UNITED STATES
DEPARTMENT OF THE INTERIOR
BUREAU OF LAND MANAGEMENTFORM APPROVED
OMB NO. 1004-0137
Expires: January 31, 2018**SUNDRY NOTICES AND REPORTS ON WELLS**
Do not use this form for proposals to drill or to re-enter an abandoned well. Use form 3160-3 (APD) for such proposals.5. Lease Serial No.
NMLC061705B

POKER LAKE UNIT 17 TWR 901H

XTO Permian Operating, LLC requests permission to make the following changes to the original APD:

Attachments:
Updated C102
Casing/Cement Design
Multibowl Diagram
Directional Plan

13-3/8" x 9-5/8" x 5-1/2" 10M RSH-2 Wellhead
Assembly, With T-EBS-F Tubing Head

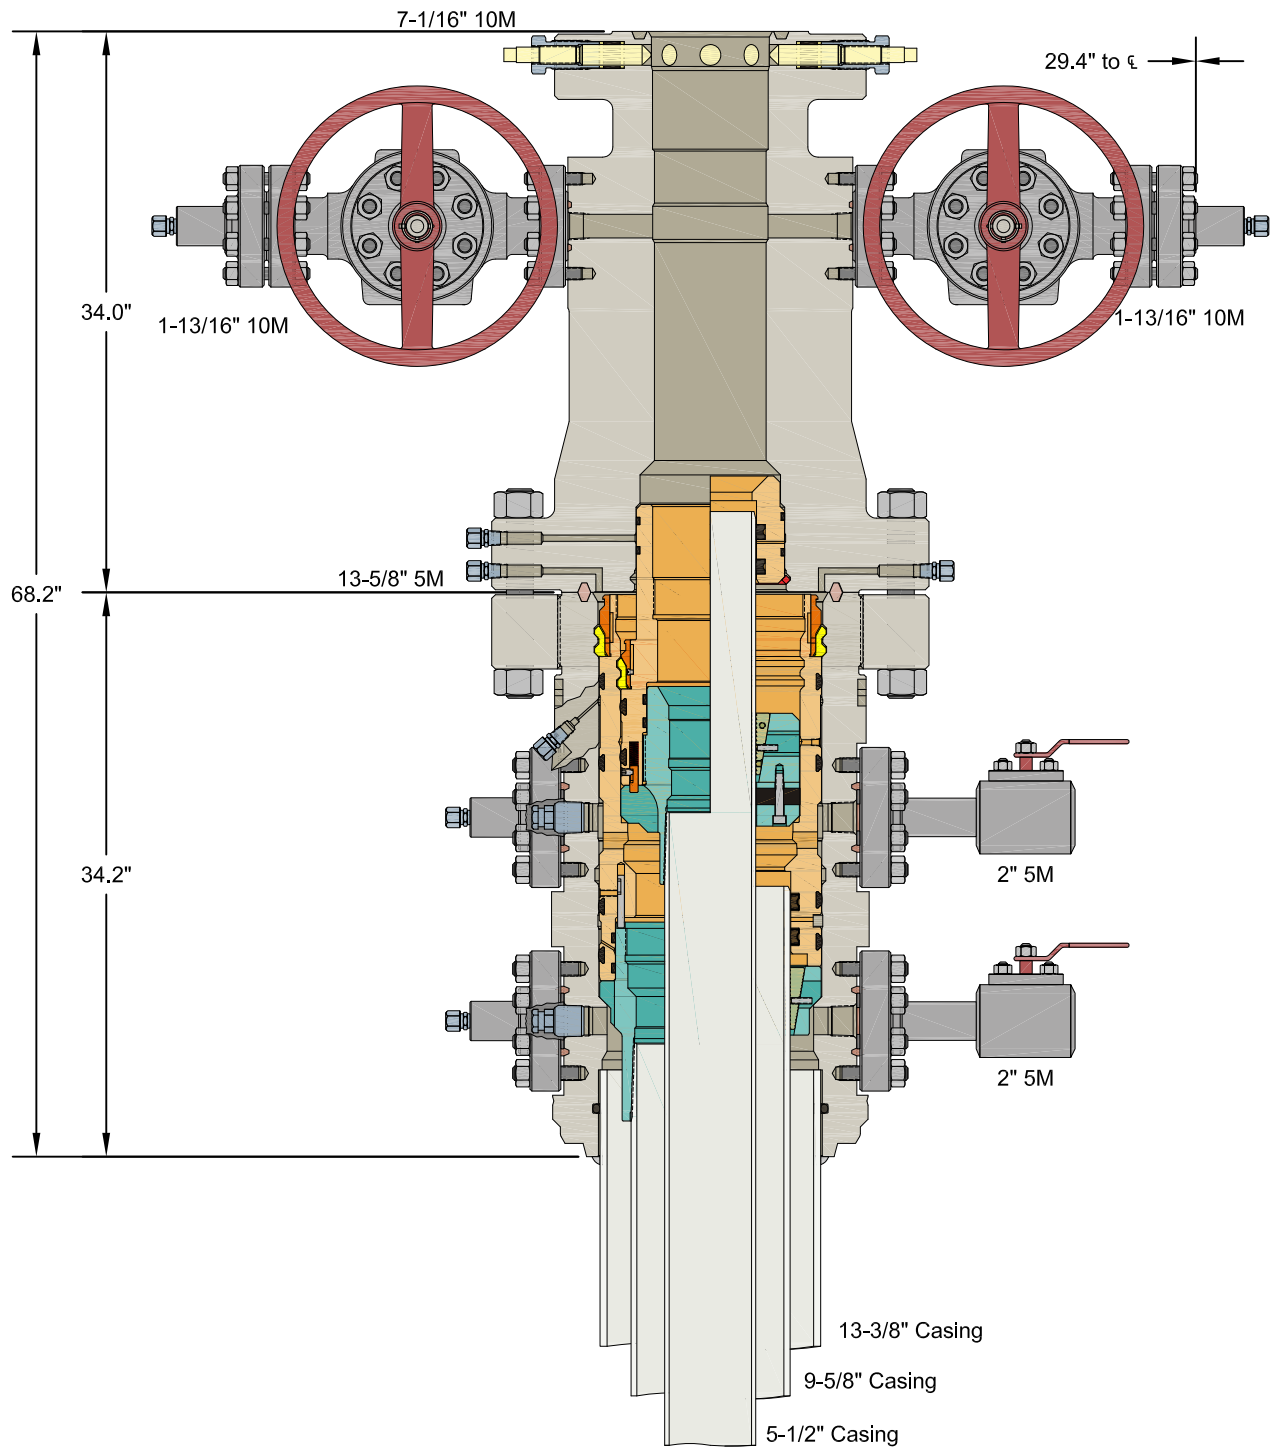
Permanent Wellhead – GE RSH Multibowl System

- A. Starting Head (RSH System): 13-3/8" SOW bottom x 13-5/8" 5M top flange
- B. Tubing Head: 13-5/8" 5M bottom flange x 7-1/16" 10M top flange
 - Wellhead will be installed by manufacturer's representatives.
 - Manufacturer will monitor welding process to ensure appropriate temperature of seal.
 - Operator will test the 9-5/8" casing per Onshore Order 2.
 - Wellhead manufacturer representative may not be present for BOP test plug installation

Plan: PERMIT Rev2 (#901H/OH)

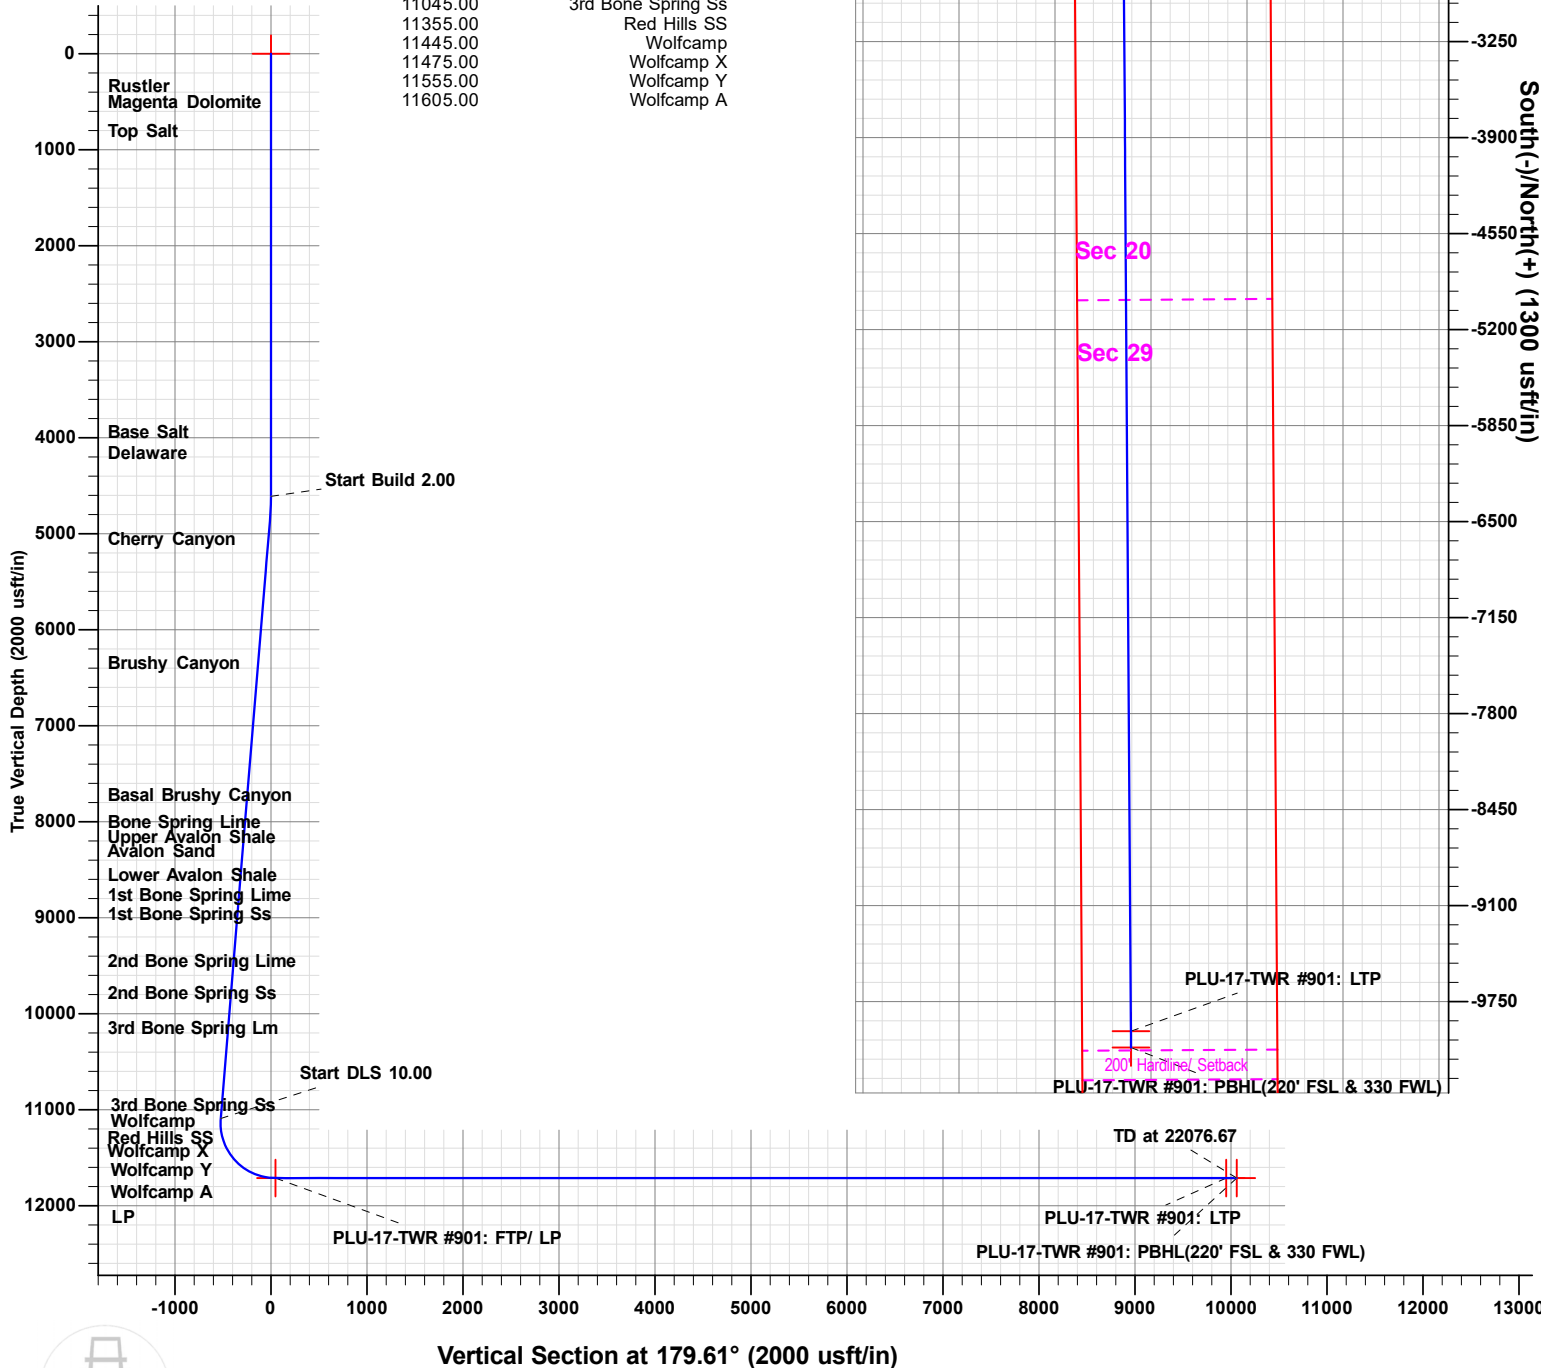
Change BHL from 2440'FNL & 335'FWL in Sec. 32-T24S-R31E to 220'FSL & 330'FWL in Sec. 29-T24S-R31E.
